Agenda Item 3
1505 Sage Court
New Residence

1505 Sage Court

Agenda Item 4
395 Oak Knoll Drive
New Residence

395 Oak Knoll Drive

2 RIGHT SIDE ELEVATION

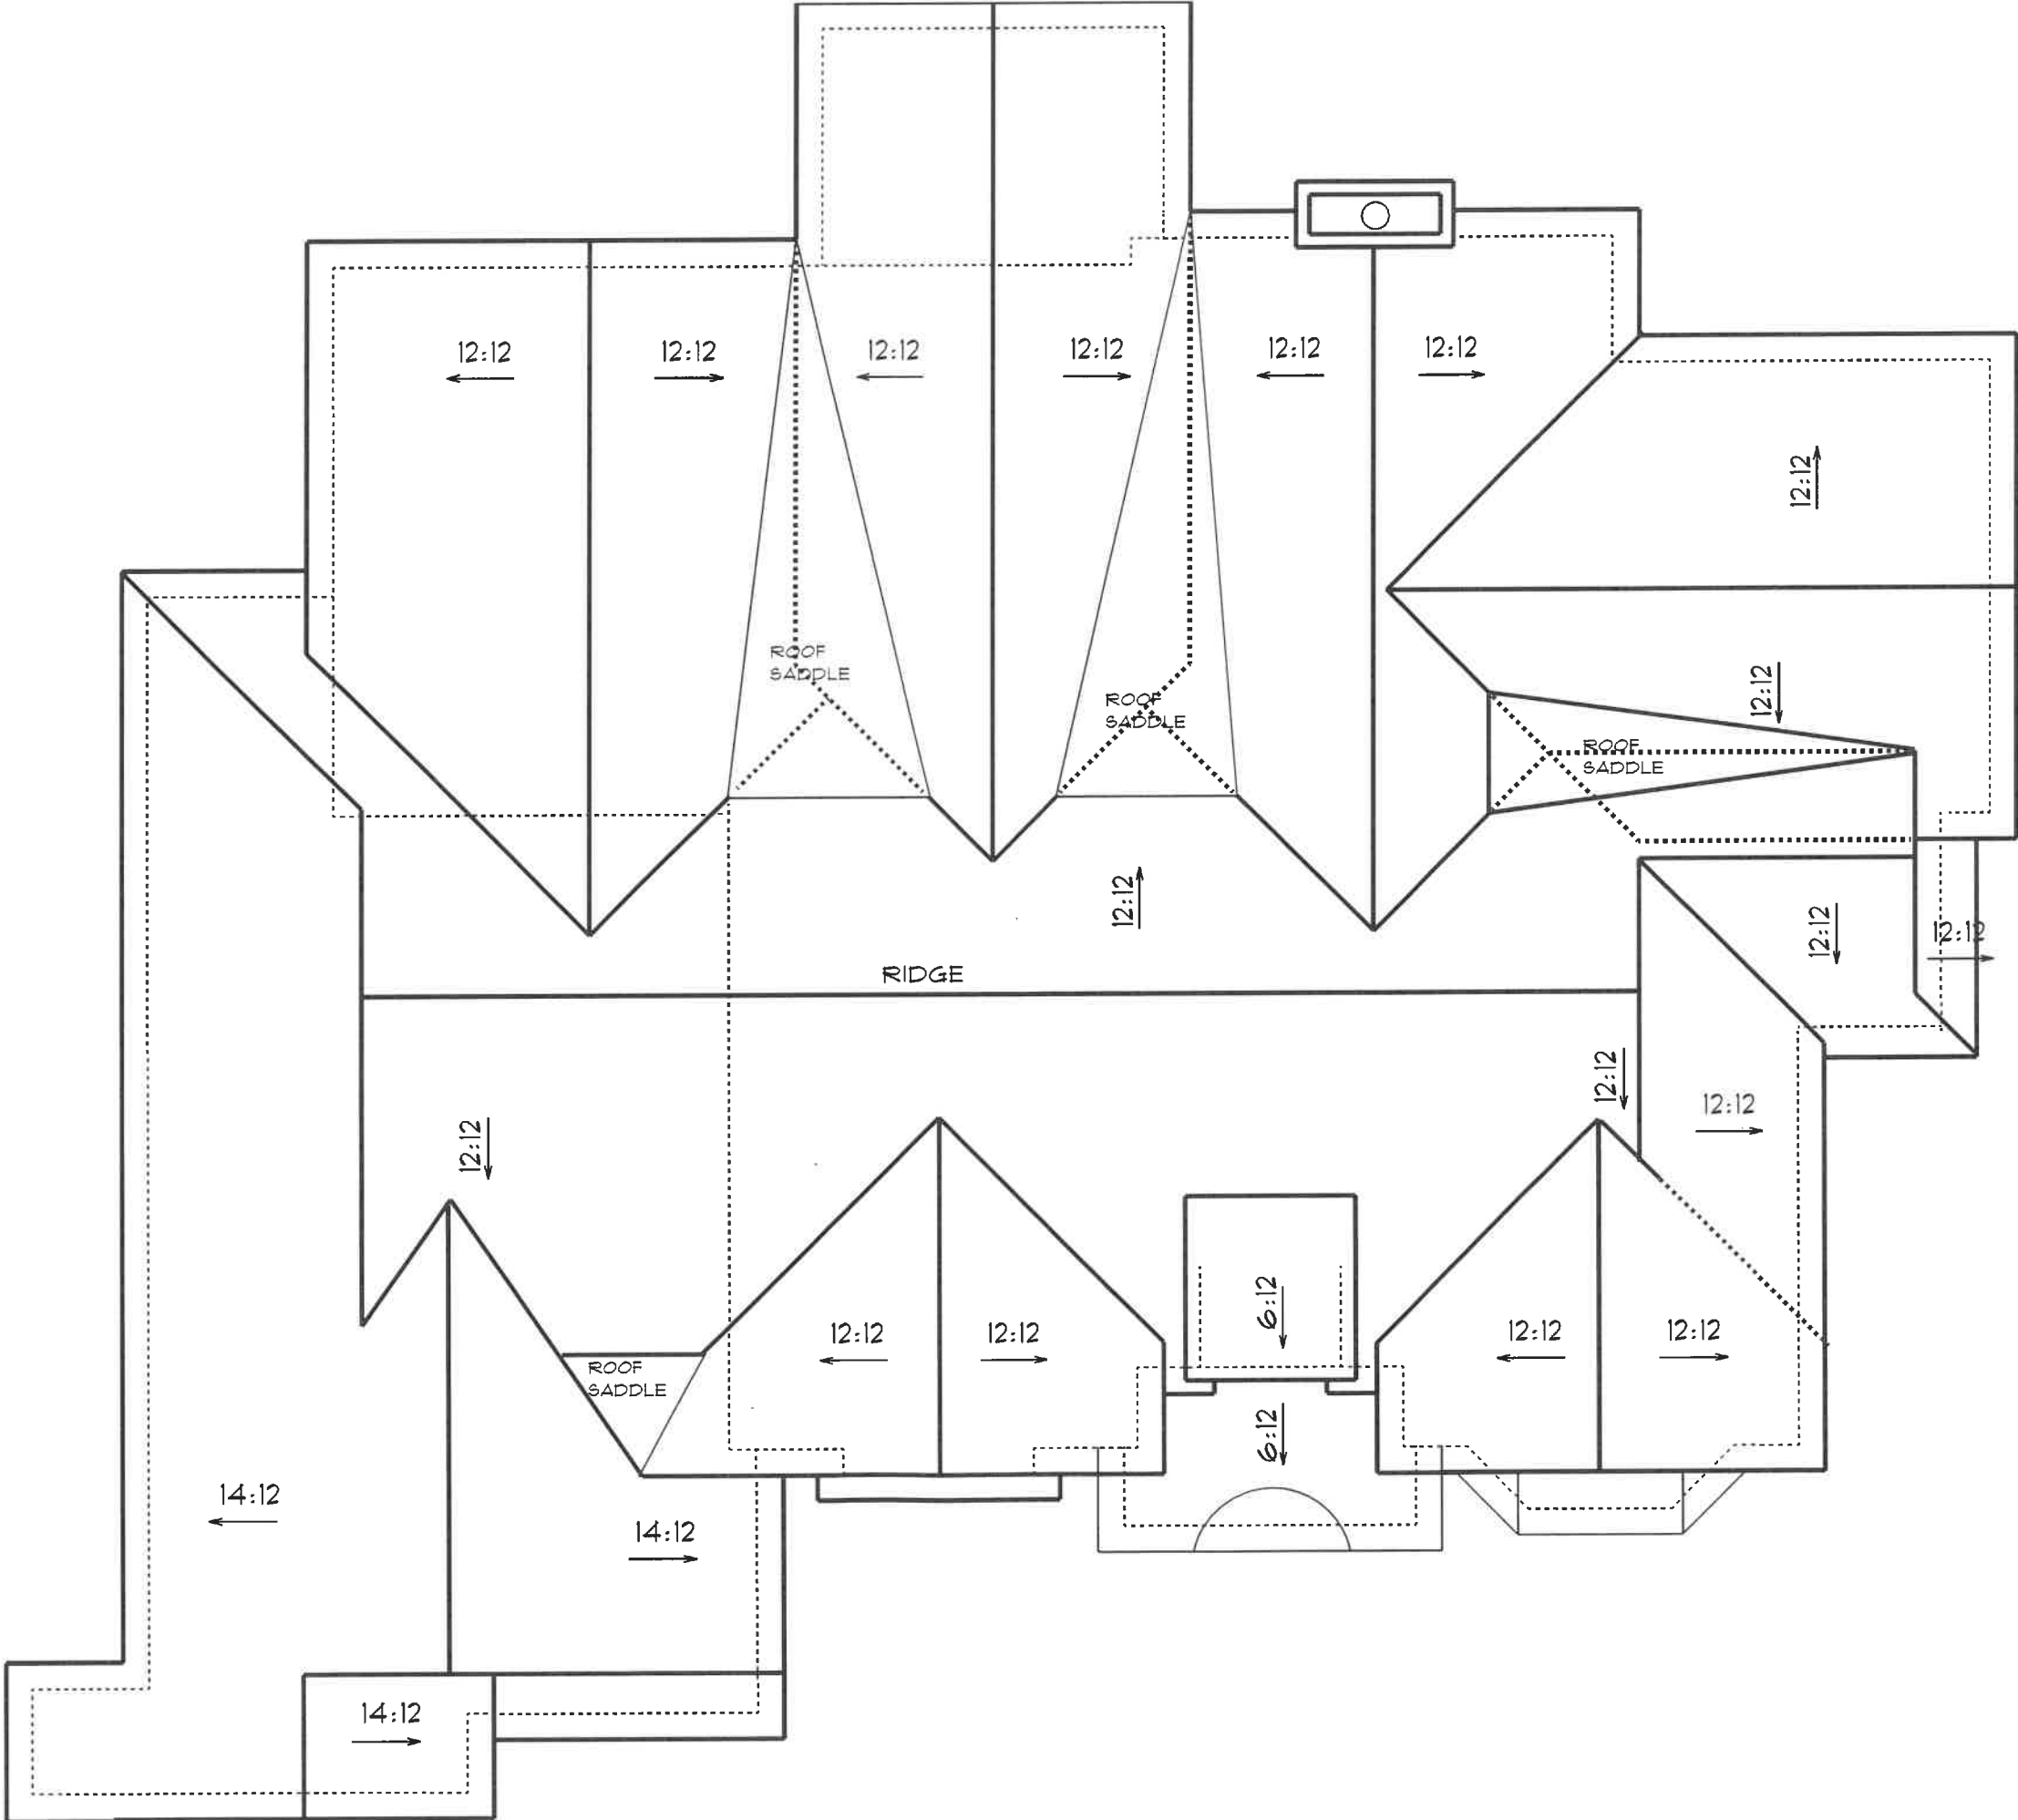
Based on information provided in the petitioner's statement of intent, the proposed residence is designed in a European Country style. The residence presents a primary two story mass with a smaller one-and-a-half story garage mass on the north side of the home. The residence features mostly steeply pitched gable roof forms. The garage as viewed from the north elevation appears to reflect roof lines that are somewhat inconsistent with the roof massing on the other elevations of the home.

- Staff recommends further study and refinement of the garage mass and roof form.

1. Conduct further study and refine the garage roof form on the north elevation to be more in keeping with the other roof forms on the home.
2. All modifications to the plans including the refinements noted above and any others made in response to Board direction or as the result of final design development, shall be clearly called out on the plan and a copy of the plan originally provided to the Board shall be attached for comparison purposes. Staff is directed to review any changes, in consultation with the Chairman as appropriate to determine whether the modifications are in conformance with the Board's direction and approval prior to the issuance of any permits.
